**Bobadil Tailings Storage
Facility Stage 11 and 12**

Embankment Raises

November 2024

ENVIRONMENT PROTECTION AUTHORITY

Figure 5: Sensitive receptors (Figure 21 of Appendix E of the EIS)

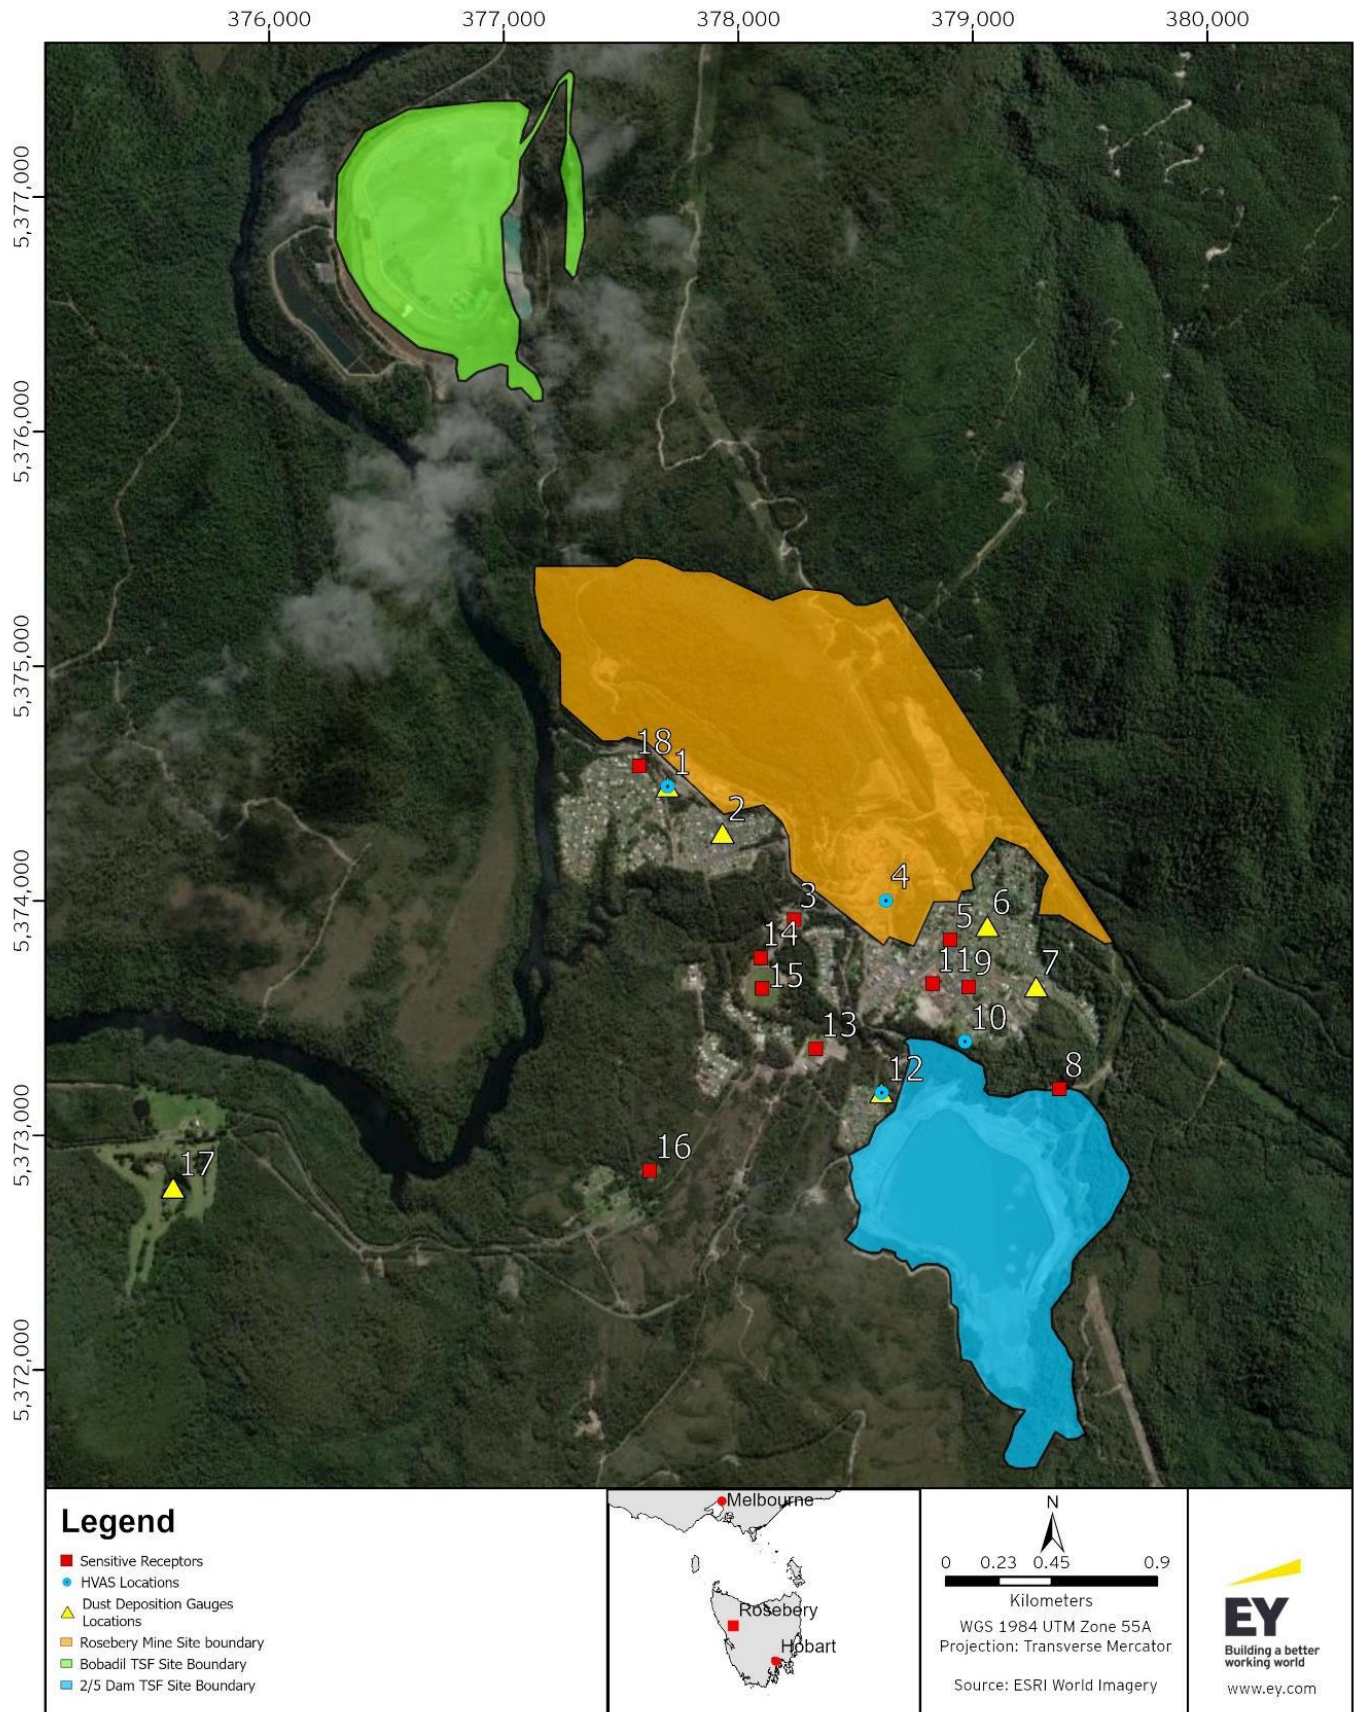
The EIS and Appendix E of the EIS nevertheless contend that no human receptors are within the areas of exceedance. This conclusion, however, is based on the locations of the sensitive receptors as shown in Figure 21 of Appendix E of the EIS and described in Table 20, and not the full extent of residences within and surrounding Rosebery. Specifically, while the location marked as 18 on Figure 21 is described as the “dwelling closest to Bobadil TSF”, the assessment does not take into account the residences along Baillieu Street.

Figure 6 Maximum and second largest 24 hour PM₁₀ concentrations for current and future scenarios in the vicinity of Baillieu Street.

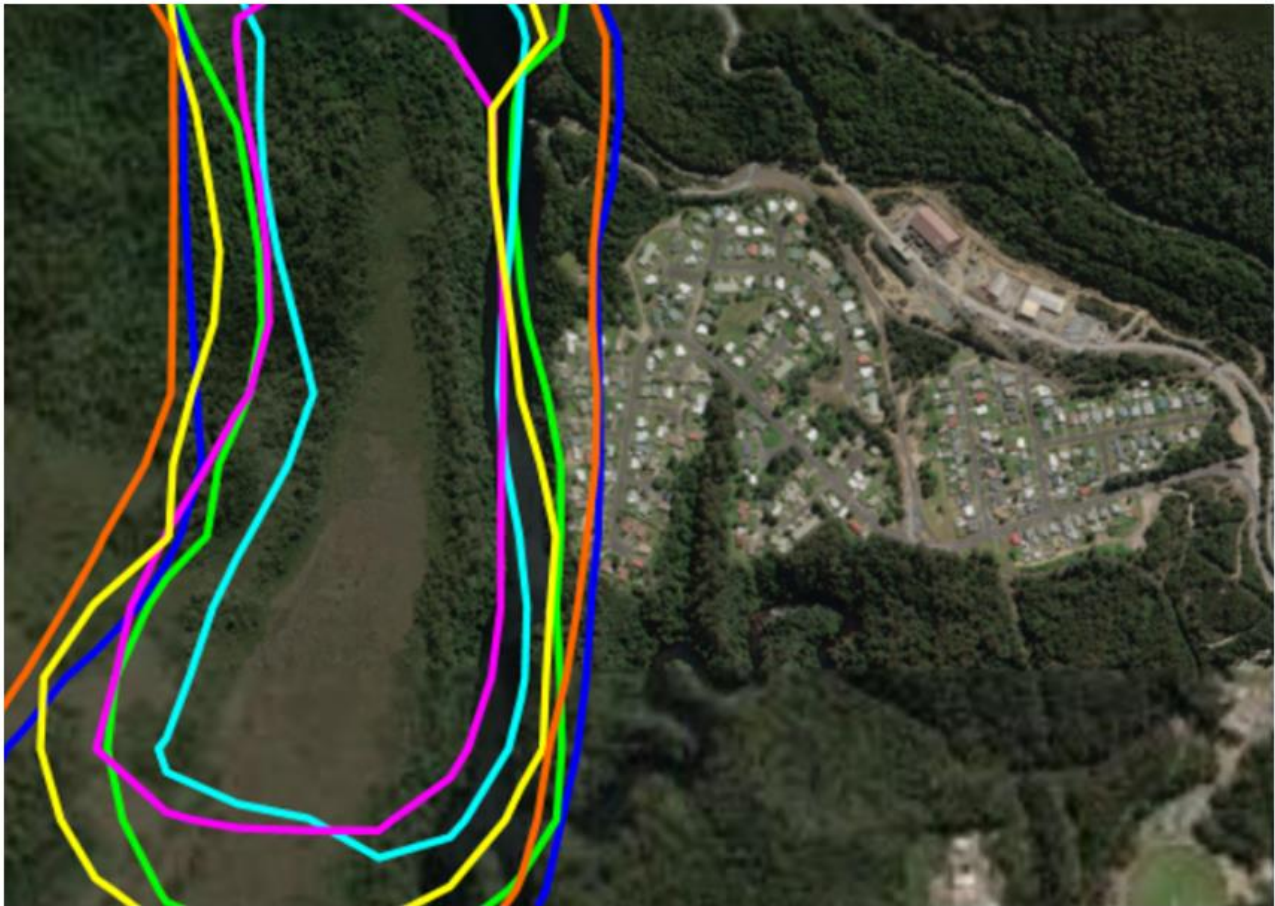
The air dispersion modelling however, shows the maximum PM₁₀ 24-hour average ground level concentration at receptors along Baillieu Street exceeds the Air EPP Schedule 2 design criteria (Figure 6). Note, this equates to an exceedance in only one 24-hour period of the model duration (1 year). It is noted that the second highest 24-hour period is below the criterion (Figure 6).

Given the area of modelled exceedance however, as illustrated in Figure 6, it is considered prudent to require installation of an air monitoring station on or near Baillieu Street (Condition **A5**). A dust deposition gauge in combination with a real time dust monitoring station (e.g. Dust Master Pro) is required to be installed prior to the commencement of construction (Condition **A5**). The final location must be determined in consultation with the EPA.

A High Volume Air Sampler (HVAS) is also required to be installed on or near Baillieu Street within 6 months of the date of this permit to allow for regulation against PM₁₀ compliance limits (Condition **A5**). The HVAS will also allow for the sampling and regulation of metals, as PM₁₀ (lead as TSP). The 6-month timeframe acknowledges the logistics and planning required to install this instrumentation.
